DECISION, CONDITIONS, FINDINGS OF FACT, AND CONCLUSIONARY FINDINGS OF THE MCMINNVILLE HISTORIC LANDMARKS COMMITTEE FOR APPROVAL OF THE ALTERATION OF A HISTORIC BUILDING AT 711 NE 3RD STREET WITHIN THE DOWNTOWN DESIGN AREA

- DOCKET:** DDR 4-18
- REQUEST:** The applicant has submitted a Downtown Design Review application to request the alteration of a historic building in the Downtown Historic District, which is listed on the National Register of Historic Place.

////////////////////////////////////
DECISION: APPROVAL WITH CONDITIONS
////////////////////////////////////

The proposed design for the reconstructed storefront window systems and entries can be seen below:

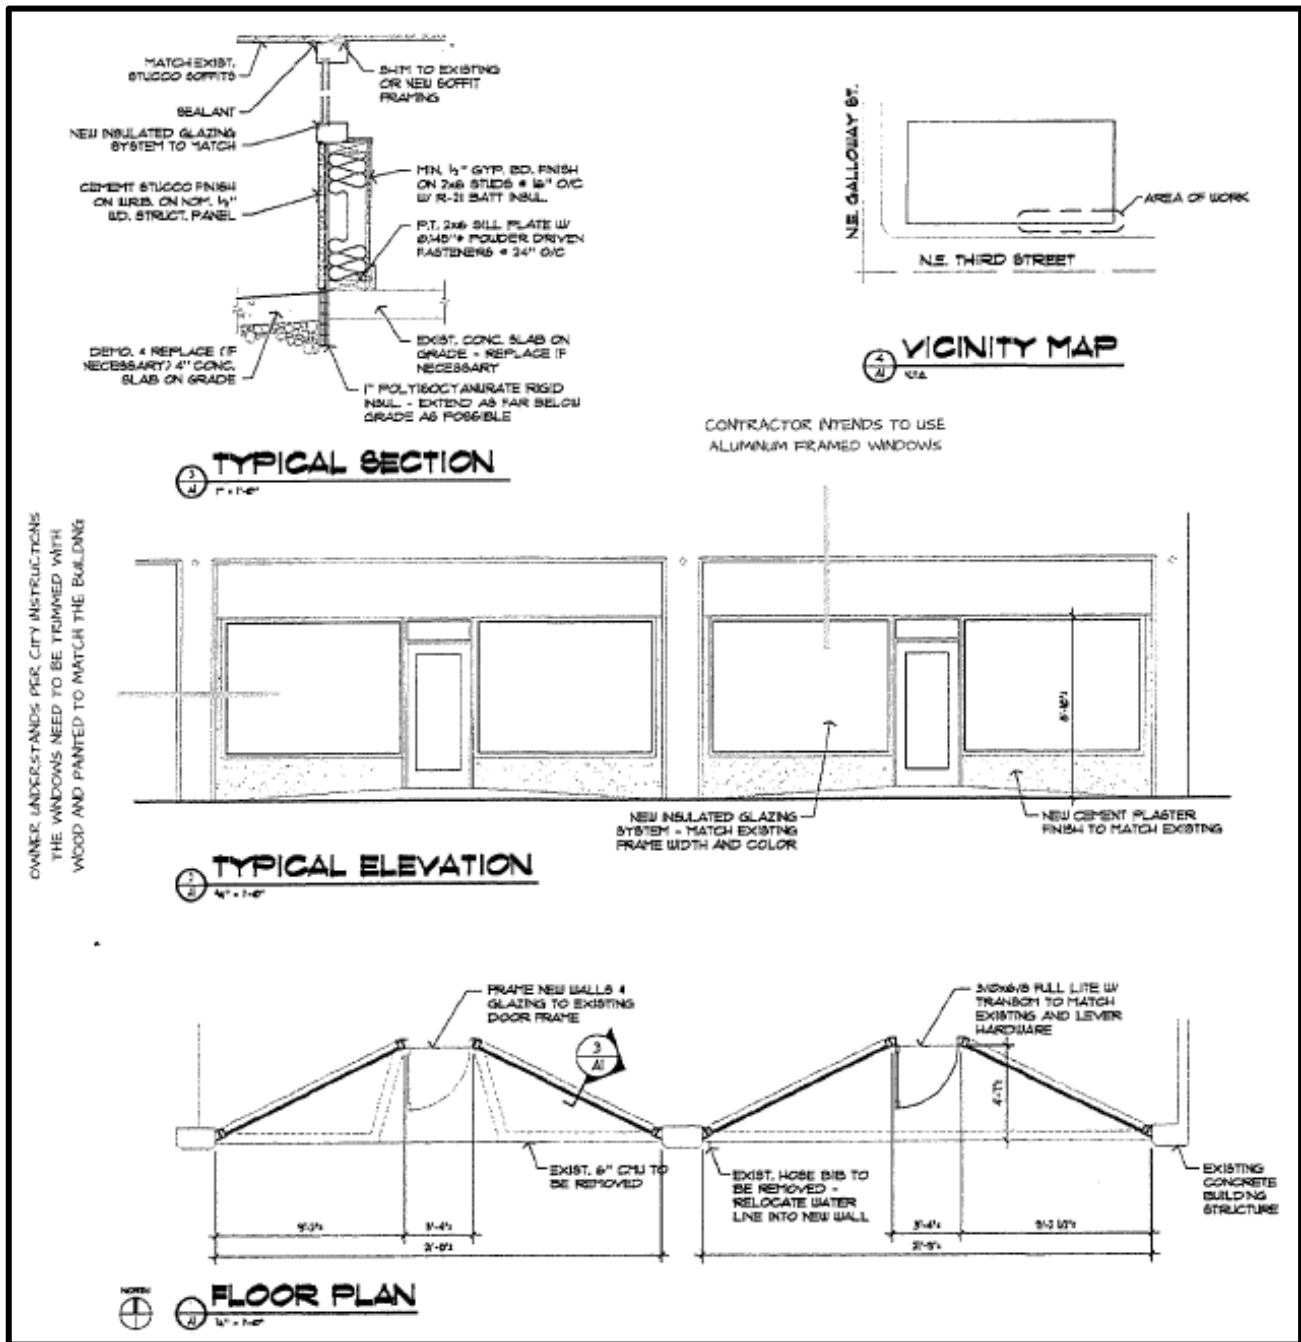
Additionally, the design has inadequate maneuvering clearance for ADA on the latch side of the doors.

The glazing that will go adjacent to the doors will need to be safety glazing as well as the glazing within the doors.

Door hardware must be ADA compliant (e.g., lever-type).

The threshold height is not indicated but must be held to a maximum of ½ inch for ADA.

1. That the stucco bulkheads beneath the storefront windows shall be painted the same grey color as the windows and window frames on the remainder of the building in order for the historic storefront bay system and columnar stucco pilasters to be more prominent. The bulkheads beneath the storefront windows along the entire south façade, including the two bays proposed to be rehabilitated and the two existing bays to the west, shall all be painted the same grey color to ensure consistency along the entire south façade.

The windows are proposed to be recessed by from the outer wall and above the bulkhead beneath the windows. The recessed windows are shown in the section below:

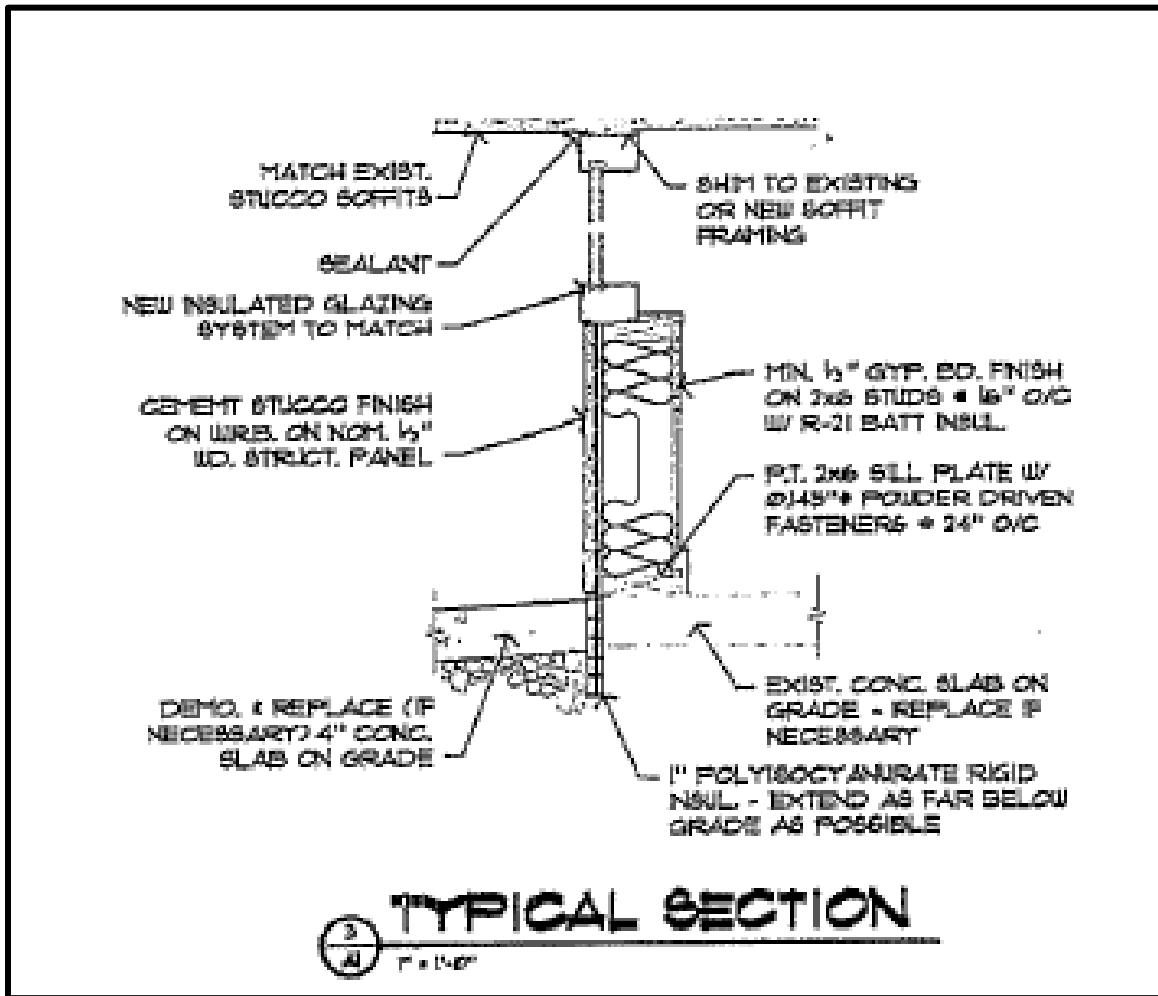
Finding: **Section 17.59.050(B)(7) is satisfied, and a condition of approval is included to ensure that the criteria is satisfied.**

In order for the historic storefront bay system and columnar stucco pilasters to be more prominent, a condition of approval is included to require that the bulkheads beneath the storefront windows be painted the same grey color as the windows and window frames. The condition of approval requires

that the bulkheads along the entire south façade be painted the same grey color for consistency along the entire south façade. This will ensure that the added building elements in the two easternmost bays, along with the other existing materials on the building, will be visually compatible with the original architectural character of the building.
